**SUNDRY NOTICES AND REPORTS ON WELLS**  
*Do not use this form for proposals to drill or to re-enter an abandoned well. Use Form 3160-3 (APD) for such proposals.*

8. Well Name and No.  
**SCHALK GULF #3A**

## PLUG AND ABANDONMENT PROCEDURE

Re: Permanent Abandonment

## Proposed P&A

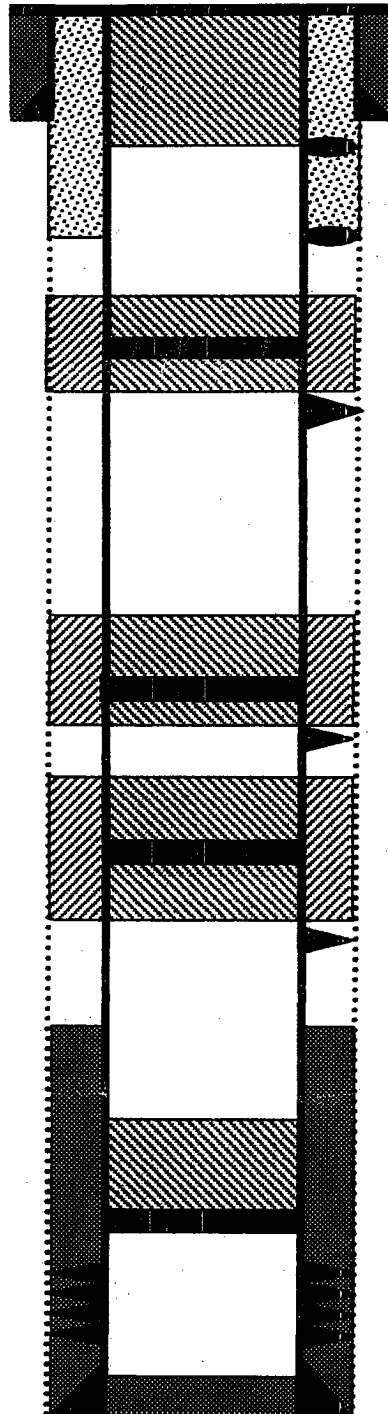
1. Plugging operations authorized are subject to the attached "General Requirements for Permanent Abandonment of Wells on Federal and Indian Lease."
2. Farmington Office is to be notified at least 24 hours before the plugging operations commence (505) 599-8907.
3. The following modifications to your plugging program are to be made:
  - a) Place the Pictured Cliffs/Fruitland plug from 4021' - 3765' inside and outside the 4 ½" casing.
  - b) Place the Kirtland/Ojo Alamo plug from 3757' - 3444' inside and outside the 4 ½" casing.
  - c) Place the Nacimiento plug from 2320' – 2220' inside and outside the 4 ½" casing.

4. Plug #2 (Pictured Cliffs and Fruitland tops, <sup>4021 3765'</sup>~~4050' – 3650'~~): Perforate 3 squeeze holes at <sup>4021'</sup>~~3965'~~. Set 4.5" cement retainer at ~~3905'~~. Establish rate into squeeze holes. Mix and pump 169 sxs cement, squeeze 138 sxs outside the casing and leave 31 sxs inside casing to cover Pictured Cliffs and Fruitland tops. PUH to 3670' and reverse circulate well clean. Shut in well and WOC.

5. Plug #3 (Kirtland and Ojo Alamo tops, <sup>3757' 3444'</sup>~~3662' – 3427'~~): Perforate 3 squeeze holes at <sup>3757'</sup>~~3662'~~. Set 4.5" cement retainer at ~~3642'~~. Establish rate into squeeze holes. Mix and pump ~~100~~ sxs cement, squeeze ~~81~~ sxs outside the casing and leave ~~19~~ sxs inside casing to cover Kirtland and Ojo Alamo tops.

6. Plug #4 (Nacimiento top, <sup>2320' 2220'</sup>~~1805' – 1705'~~): Perforate 3 squeeze holes at <sup>2320'</sup>~~1805'~~. Attempt to establish rate into squeeze holes if the casing pressure tested prior to perforating. Set 4.5" cement retainer at ~~1755'~~. Establish rate into squeeze holes. Mix and pump 46 sxs cement, squeeze 35 sxs outside the casing and leave 11 sxs inside casing to cover the Nacimiento top. PUH to 355'.
